Access Compliance Report Public Rights-of-Way (Curb Ramps)

Main Street: TERRASTAR_LN		Cross Street: BROOKWOOD_ST		Location:	W
ADA ID: RPAT211101094727	Ramp Type: Type 4 - Parallel	Initial Pass/Fail: Pass	Overall Compliance: No	Severity Score:	10

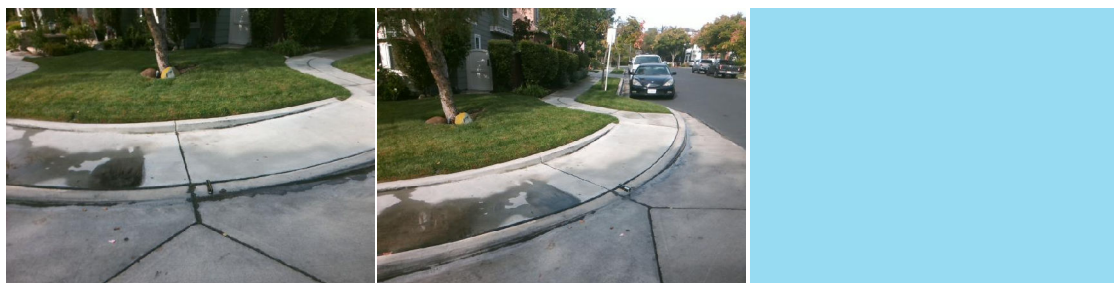
R204.3, R305, STD 1115

Remove & Replace Curb Ramp With Two New Directional Ramps or Equivalent.
